**STAFF REPORT
FOR THE HISTORIC REVIEW BOARD**

FILE NUMBER: DR-12-01

REQUEST: Rear addition/converted porch demolition and construction

1745 4th Avenue
Plot Plan
McCoy - Rising Residence
New Foundation

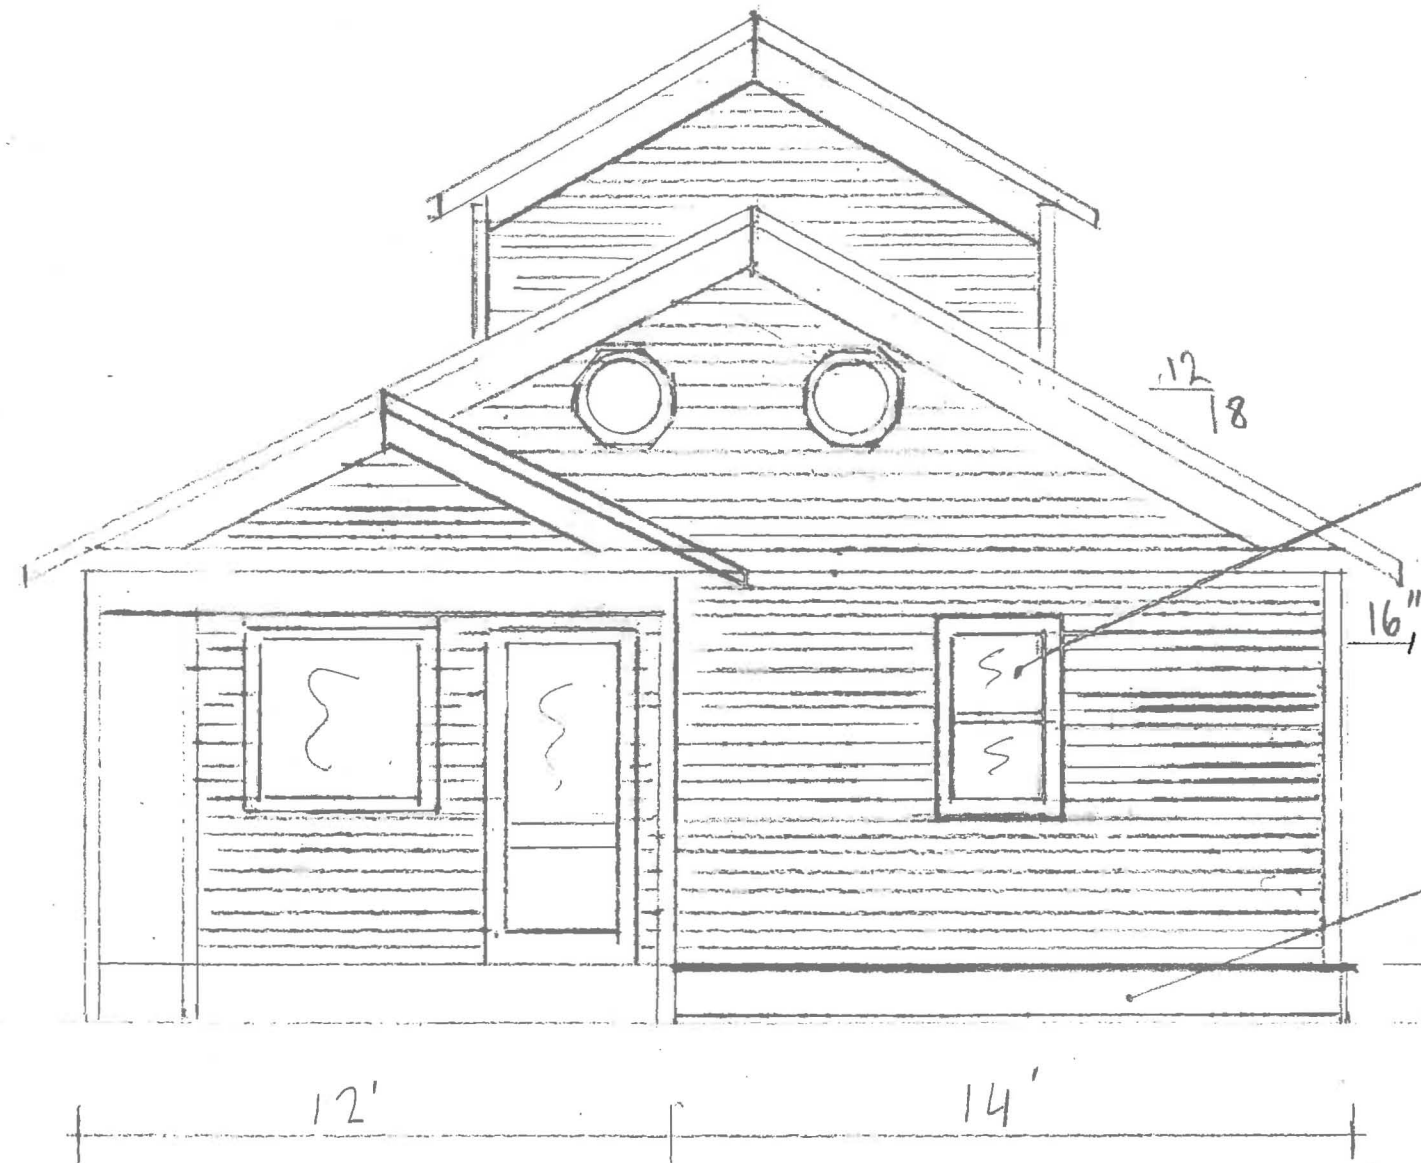
FINDING NO. 2: Criterion 1 does not apply since this is a rear addition. For #2, the proposed rear addition will not decrease the existing side yard setback, which is approximately 60 feet to the west and 20 feet to the east. This is far in excess of the required five-foot setback. Criterion 3 does not apply. For #4, the lot depth is 150 feet, and the rear of the proposed structure will be approximately 54 feet from the rear lot line, far exceeding the 20 feet required. Criterion 5 does not apply. For #6, lot coverage, the total is approximately 11 percent, which is far less than the 50 percent permitted. This low percentage is due to the large lot size of approximately 15,000 sq. ft. The applicable criteria are met.

PROPOSED
 EAST ELEVATION (REAR)
 1/4" = 1' SCALE

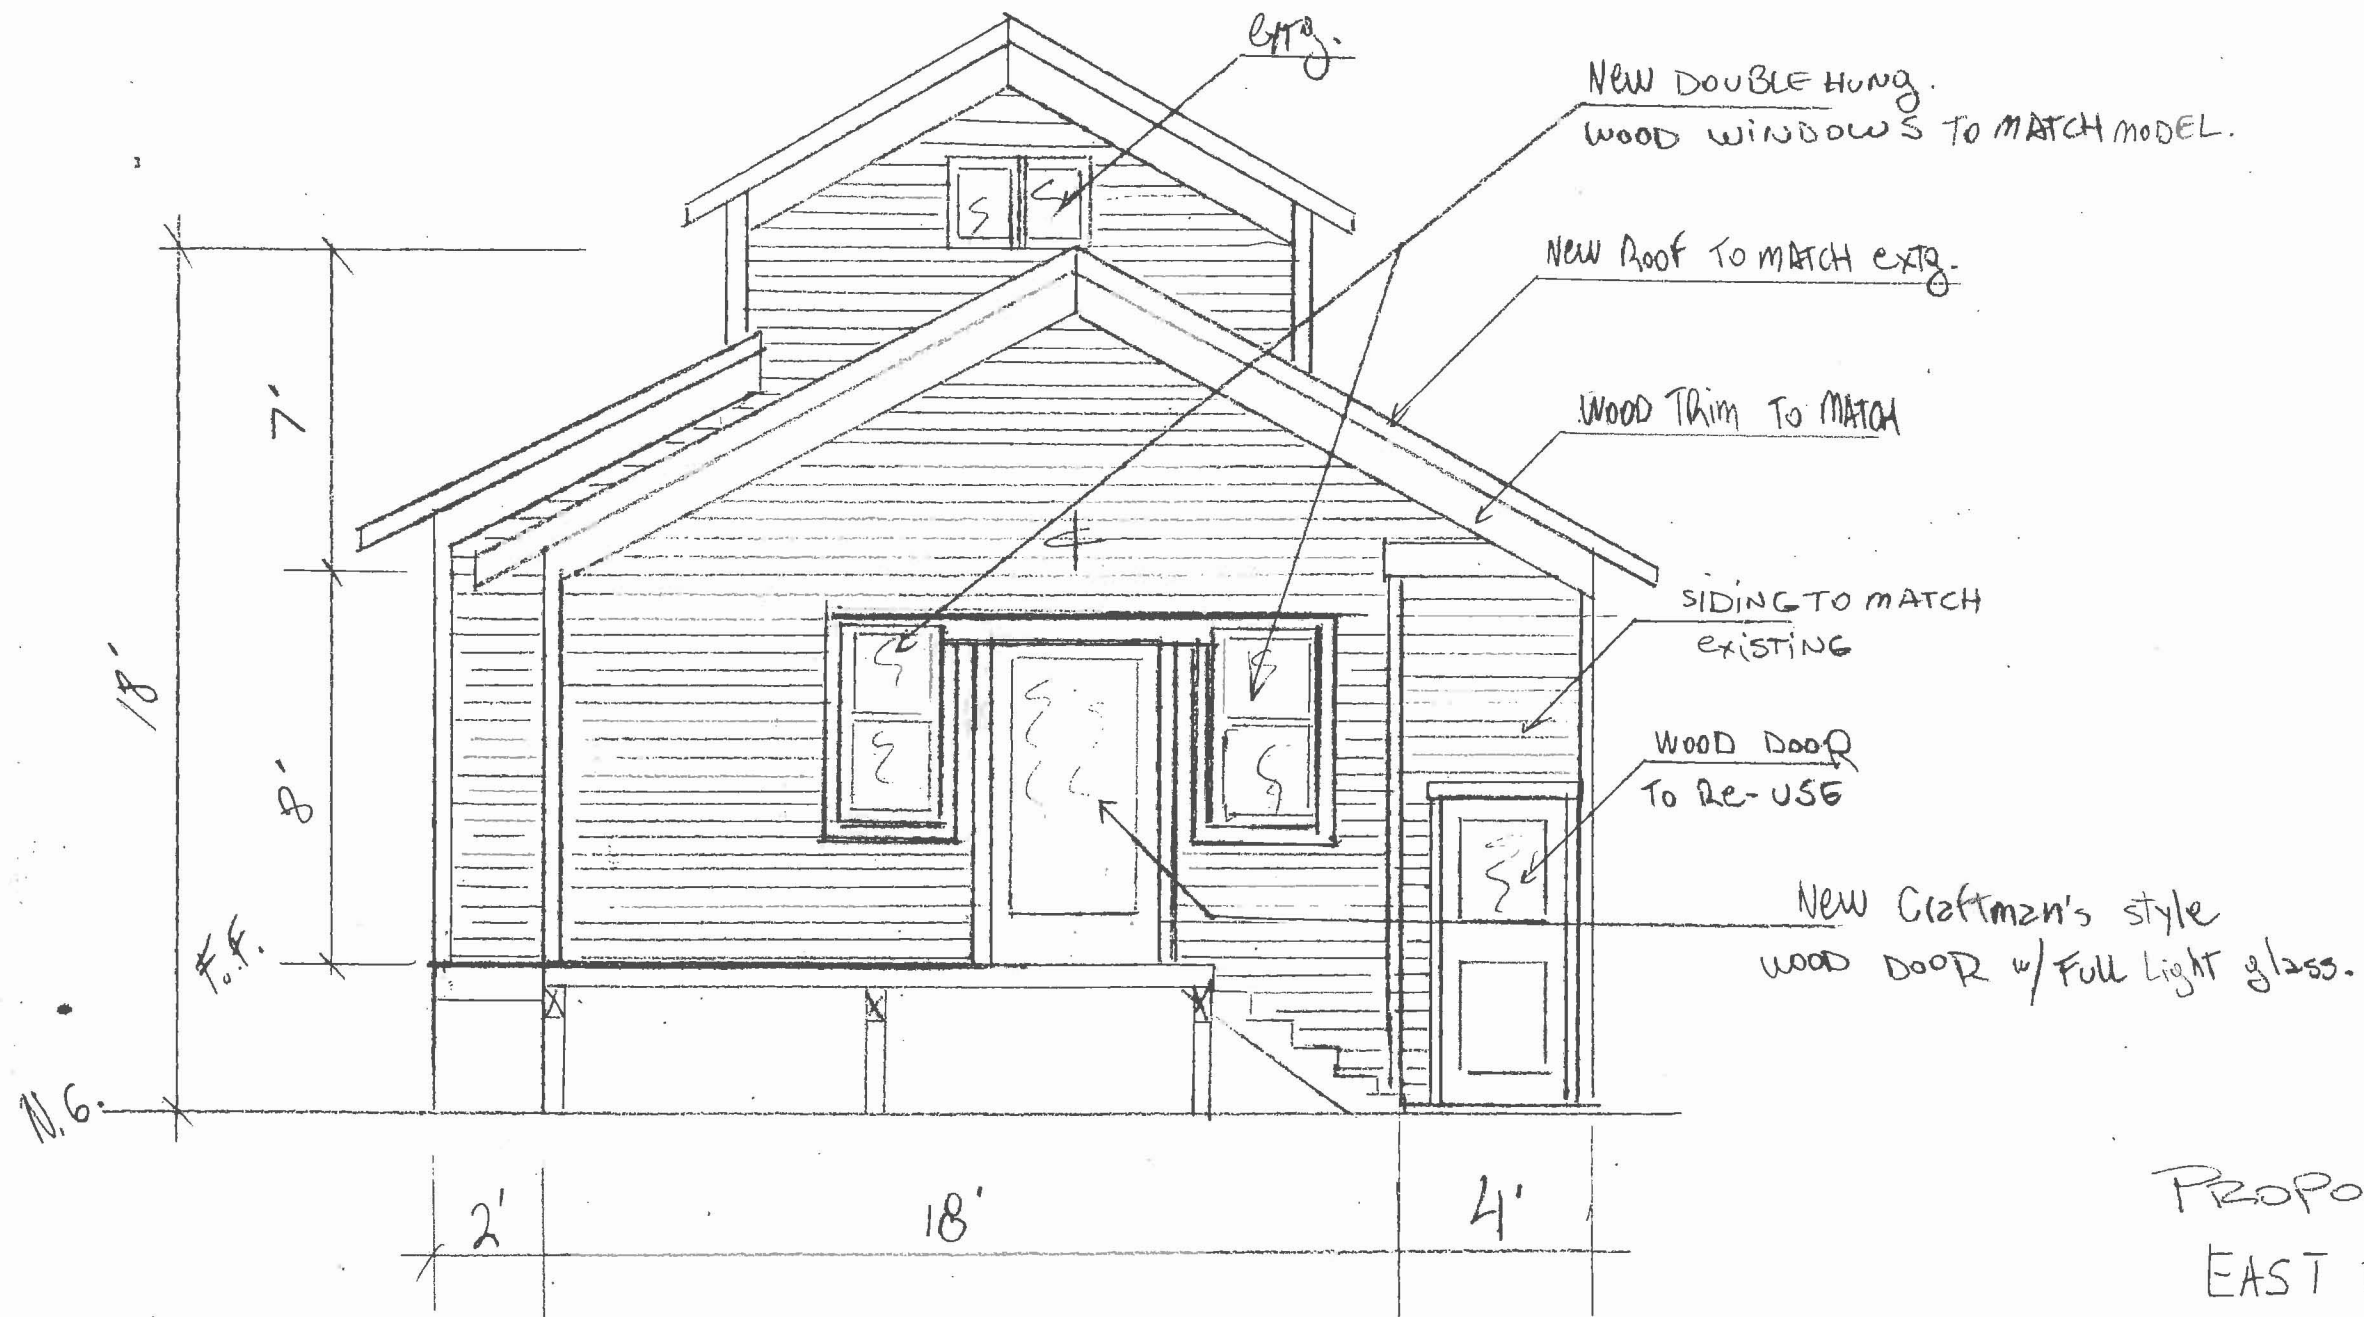
FINDING NO. 3: Criteria 2-4 do not apply. For Criterion 1, the proposed addition will be approximately 15 feet from grade. The rear yard slopes gently downward. The peak of the roof on the addition is approximately 8 feet lower than the peak of the roof on the main portion of the

residence. For Criterion 5, the existing height of the main section of the residence is preserved. The rear addition does not significantly modify the mass of the house as seen from the right-of-way. It will be minimally visible from the right-of-way. The applicable criteria are met.

FINDING NO. 4: For #1, the proposed addition at its widest point is 22 feet, less than the maximum permitted. For #3, the proposed addition does not have a horizontal orientation. Criteria #2 and #4 do not apply. The applicable criteria are met.
